1 **DRAFT SAFETY EVALUATION BY THE OFFICE OF NUCLEAR REACTOR REGULATION**
2 **TOPICAL REPORT 3002010613, “BENCHMARKS FOR QUALIFYING FUEL REACTIVITY**
3 **DEPLETION UNCERTAINTY—REVISION 1” AND TOPICAL REPORT 3002010614,**
4 **“UTILIZATION OF THE EPRI DEPLETION BENCHMARKS FOR BURNUP CREDIT**
5 **VALIDATION—REVISION 1”**
6 **PROJECT NO. 689/DOCKET NO. 99902028**

Figure 1. Results of the Linear Model Fitting.

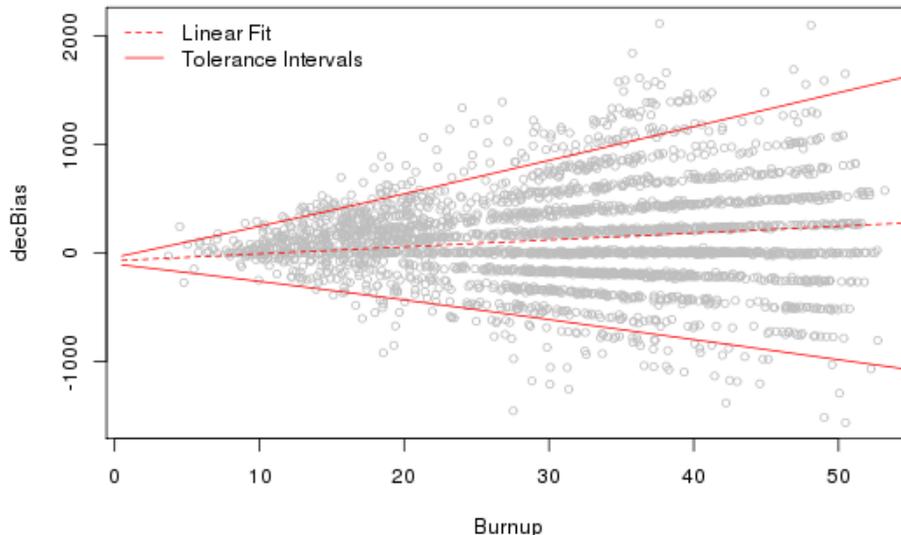
The results of the analysis assuming a linear function for the average decrement bias as a function of burnup are shown in Figure 1. The correlated heteroskedastic error structure within each sub-batch was assumed to be an AR(1) (with scaling parameter of 0.83 and a single stationary variance for all sub-batches) multiplied by the burnups.

Figure 2. Results of the Quadratic Model Fitting.

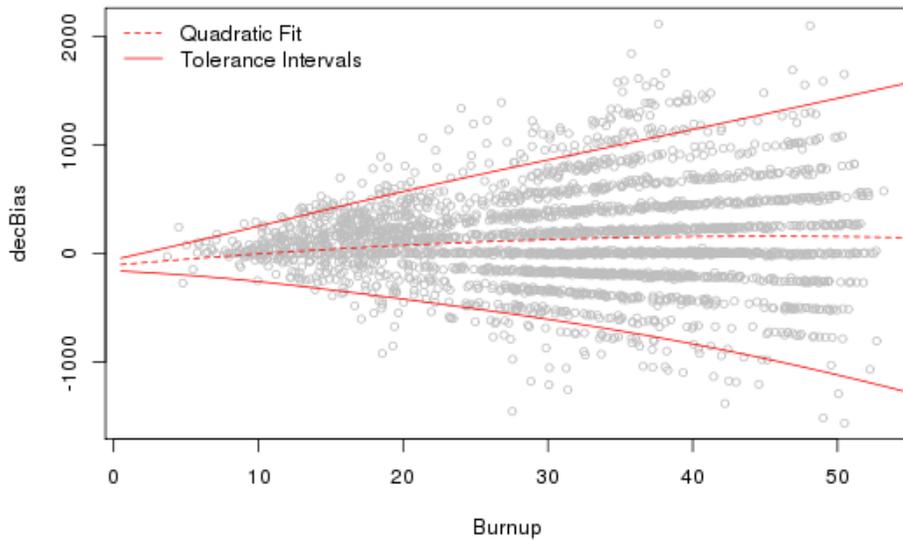
7 The results of the analysis assuming a quadratic function for the average decrement bias as a
8 function of burnup are shown in Figure 2. The estimate of the stationary standard deviation was
9 14.14. So the estimate of the standard deviation of the decrement biases for a burnup of x is
10 $14.14x$. The one-sided upper 95/95 tolerance interval fails to include 146 of the 2856 data
11 points (5.112 percent). The one-sided lower 95/95 tolerance interval fails to include 85 of the
12 2856 data points (2.976 percent). The estimate of the quadratic term is not very statistically
13 significant (the t -value is only -1.66), so the linear model analysis is preferred.

Figure 3. Plot of the Decrement Bias divided by Burnup.

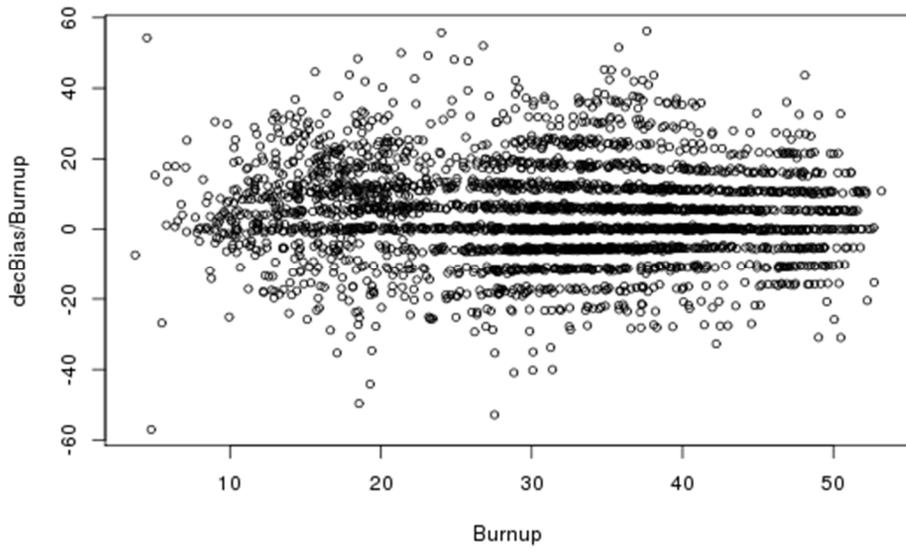
16 Figure 3 supports the assumed heteroskedastic error structure because dividing the decrement
17 biases by the burnups produces a substantially more homoscedastic looking data plot. Some
18 obvious structure in the data is not accounted for in the modeling. The lines of data are not
19 explained by the sub-batching of the data. This type of structure is likely caused by the use of
20 discrete burnup multipliers in the error deduction algorithm described in Section 6.4, "Iteration
21 Implementation," of the EPRI benchmark report.

22 The tolerance intervals may be viewed as being conservative as no attempt was made to
23 remove measurement error from the decrement bias errors.
